Office Action Summary

10/527,935

DRABAREK ET AL.

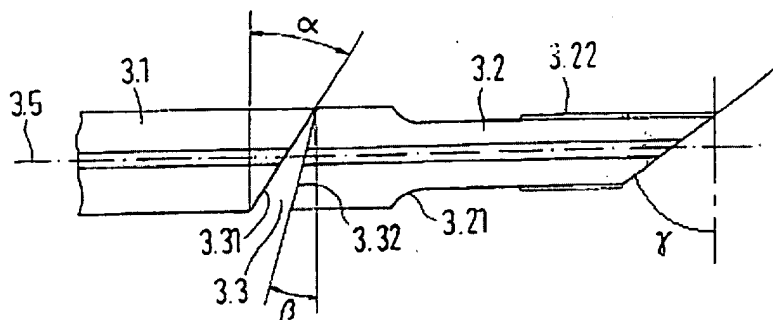
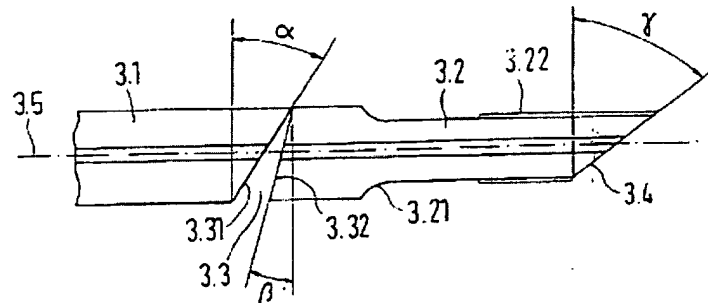
- a. The recitation of "an angle of inclination of the exit surface to the normal of an optical probe axis of the probe-optical fiber unit" in claim 11 is indefinite. The recitation is indefinite in that there are at least two possible ways of determining the claimed angle as shown in the figures below:

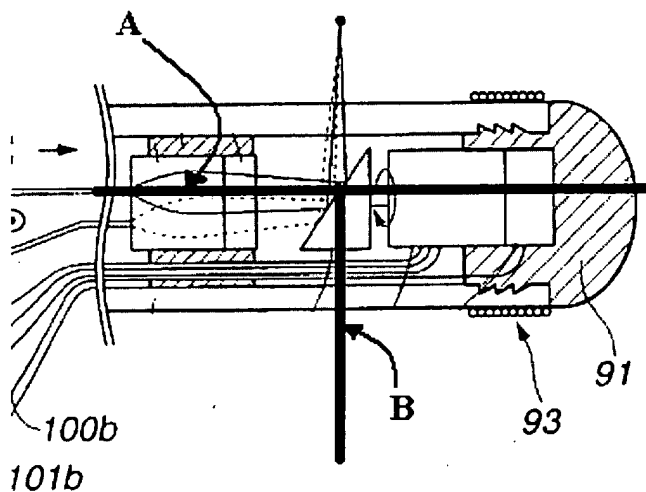
- c. The recitations “slantwise” in claim 1 and “jacket-like” in claim 13 are indefinite.
3. Claims 11-20 are rejected under 35 U.S.C. 112, second paragraph, as being incomplete for omitting essential structural cooperative relationships of elements, such omission amounting to a gap between the necessary structural connections. See MPEP § 2172.01. The omitted structural cooperative relationships are: There are multiple axis of a probe, and the claim does not specify clearly which is being referred to. There is at least an axis along the length of the optical fiber and there is an axis for the exit of the probe. Please see the figure below showing the axis (A) along the length of the optical fiber and an axis (B) for the beam at the exit of the probe of a prior art.
